**Town of Surfside
PLANNING & ZONING BOARD
AGENDA**

February 25, 2021 – 6:00 p.m.

- 1. Call to Order/Roll Call**
- 2. Town Commission Liaison Report – Mayor Charles Burkett**
- 3. Approval of Minutes –**
 - January 21, 2021
 - January 28, 2021
 - February 11, 2021
- 4. Applications:**
 - A. 8851 Harding Avenue – New 2 Story Multifamily Building**
 - B. 624 92 Street – Garage Conversion to Master Bedroom**
 - C. 8841 Froude Avenue – New Addition in Rear of House**
- 5. Next Meeting Date: March 25, 2021**
- 6. Discussion Items:**
 - A. Future Agenda Items**
- 7. Adjournment**

**Town of Surfside
SPECIAL PLANNING & ZONING BOARD
AGENDA**

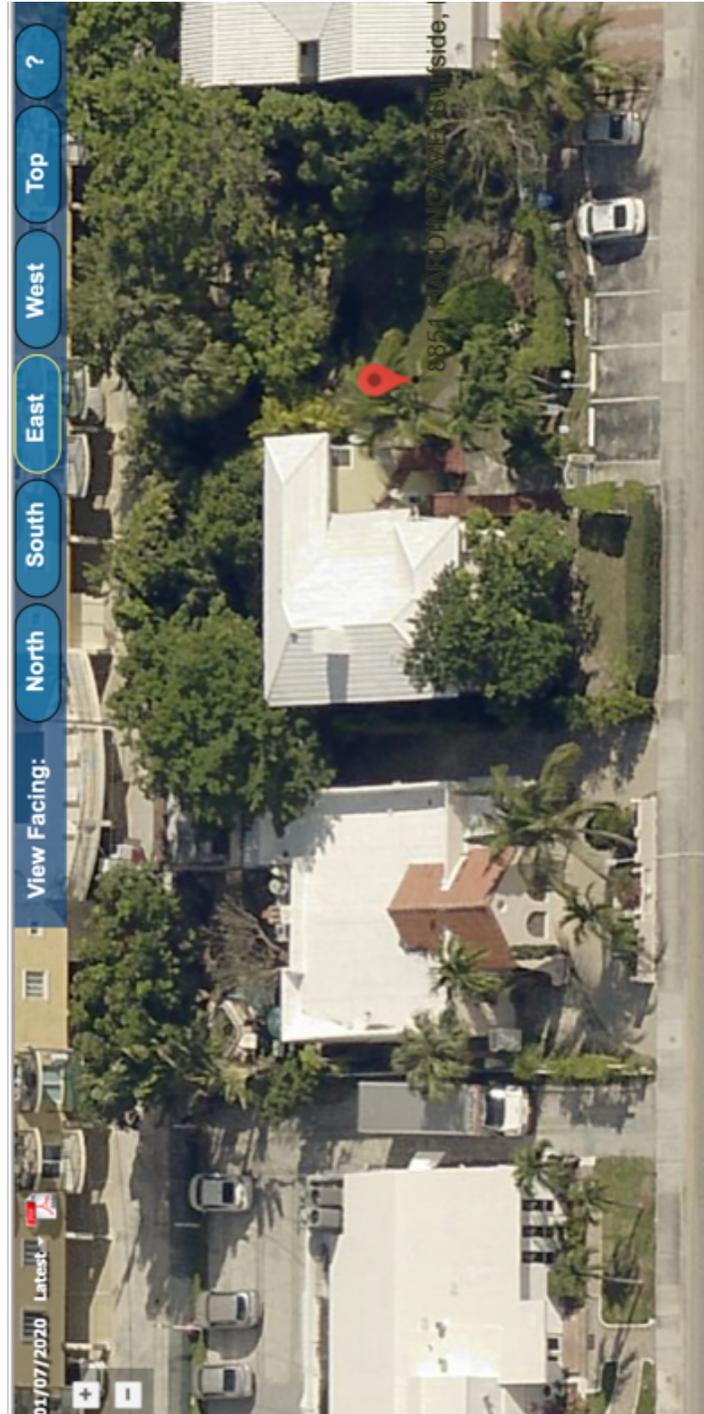
Prior staff reviews found the application complied with Town Zoning requirements except for one issue. The project requires a loading zone and the Florida Department of Transportation only approved one curb cut. The proposed remedy places the loading zone in the aisle of the underground parking garage which limits the service vehicles to a smaller size. This revision requires a variance.
